Lilypad – PowerSupply

TITLE: \${PROJECTNAME}		LillyPad
Document Number:		REV: v18
Date: \${CURRENT_DATE}		Sheet: \${#}/\${##}
Size: User Date:		Rev:
KiCad E.D.A. eeschema 7.0.6		Id: 1/1

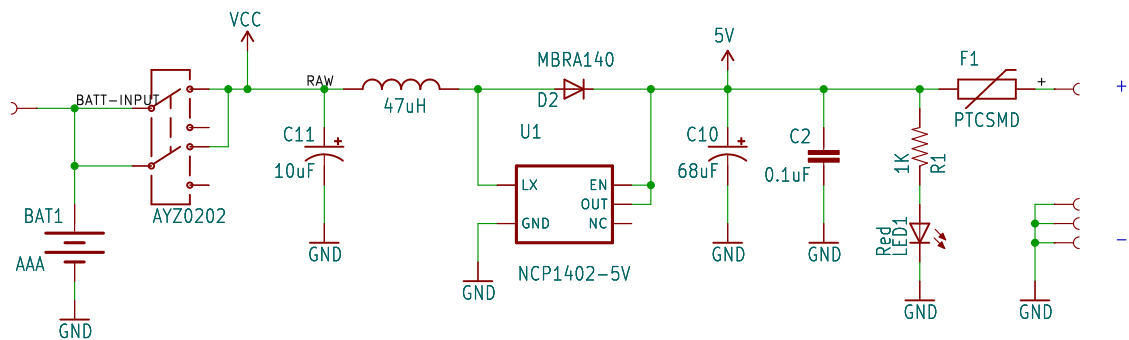
v18 Fixes:
* U1 changed from NCP1400 to NCP1402
* C10 changed from 47uF to 68uF
* L1 changed from 22uH to 47uH
* No changes to PCB design
